Reply to Office Action of January 24, 2006

Appln. No. 10/657,403

Amendment dated March 30, 2006

Remarks/Arguments

FIG. 3

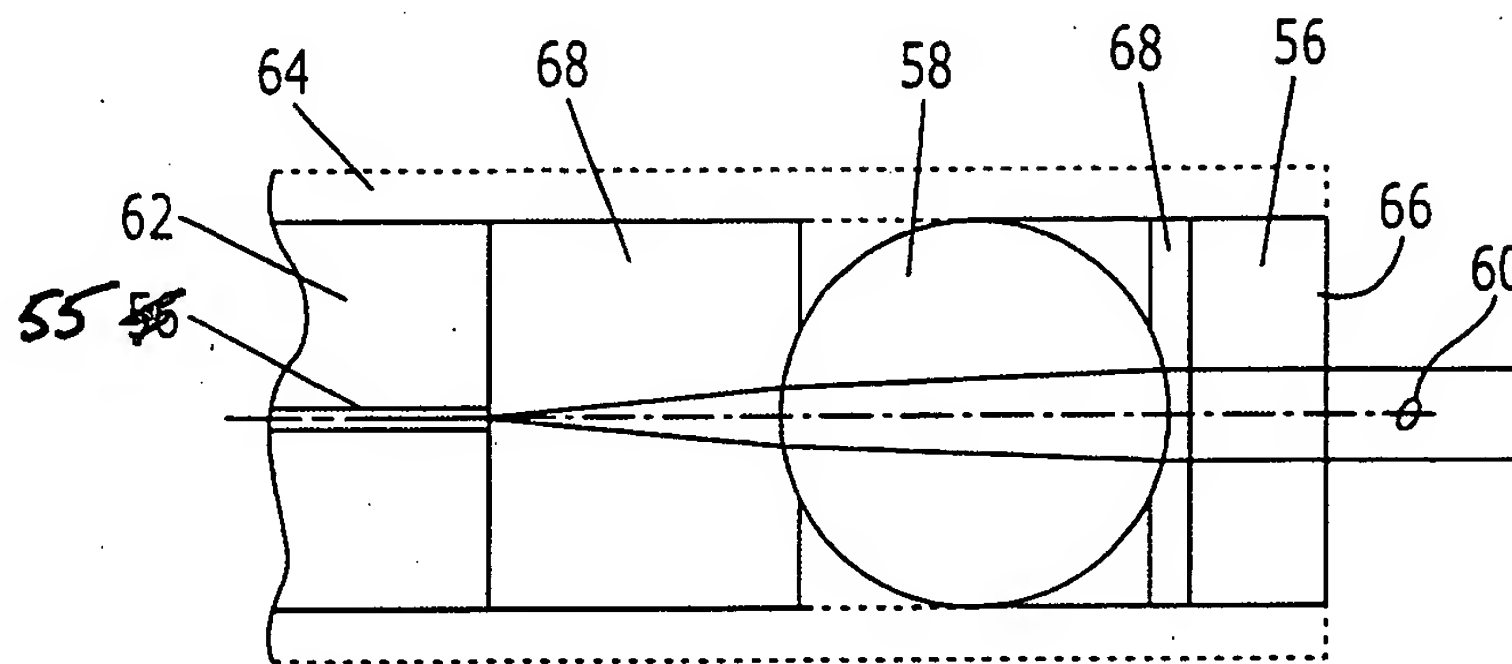
With the consent and approval of the Examiner, Applicants propose to amend Fig. 3 as shown in red in the following sketch:

Applicants propose to amend Fig. 3 of the drawings as indicated in red on the indicated sketch. The change here is to have reference numeral 56 refer to the interface optical element, and to use reference numeral 55 to refer to the optical fiber, as discussed *supra* with respect to the changes to the specification. Clearly, these proposed changes to the drawing do not seek to add "new matter". A new drawing figure to replace Fig. 3 is submitted herewith in the appendix.

In reviewing the specification, it was noted that an error appears in paragraph [0045]. That paragraph, as originally drafted, used reference numeral 56 to refer to both the "interface optical element", and to the "optical fiber". Accordingly, paragraphs [0045], [0046] and [0049] have been amended so that the optical fiber is referred to by reference numeral 55. Thus, in the specification, reference numeral 56 refers to the interface optical element, and reference numeral 55 now refers to
